UNITED STATES PATENT AND TRADEMARK OFFICE

Office Action Summary

10/826,328

LAI, KUO-YEN

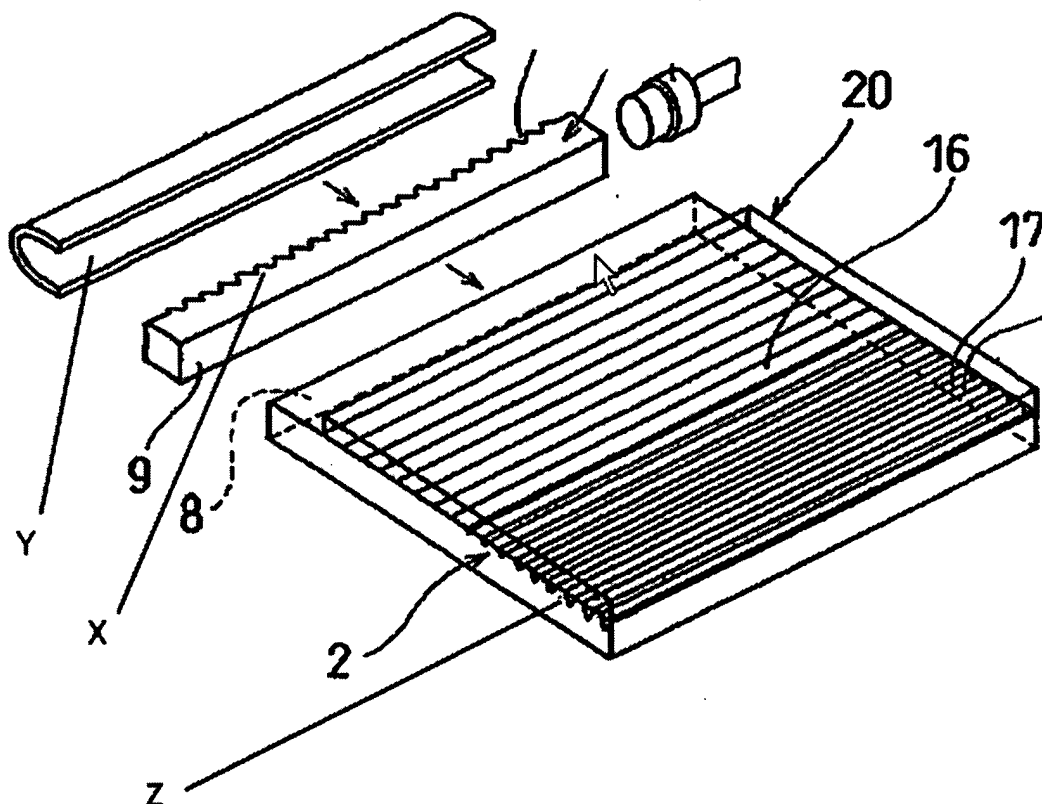
Asakawa et al. teaches backlight system for a display panel comprising a point light source 4, a first light reflecting unit 12,13 to reflect and to spread the incident light beam from the light source in a first direction, and a second light reflecting unit 16 to spread the reflected light from the first light reflecting unit in a second direction and to

project the reflected light from the second light reflecting unit onto a display screen 10 as a backlight

As for claim 2, Asakawa further teaches the first light reflecting unit having a ladder planar contour (indicated below as X) and a curved surface contour reflecting surface (indicated below as Y).

As for claim 3, Asakawa further teaches the second reflecting unit having a Ladder convex contour sloped reflecting surface (indicated above as Z).

As for claim 7, Asakawa further shows that the second reflecting unit lies over the first reflecting unit as shown in figure 2, rotated 180 degrees.

As for claim 8, Asakawa further teaches that the first reflecting unit 12 is integrated with the second reflecting unit, as seen in figure 2.
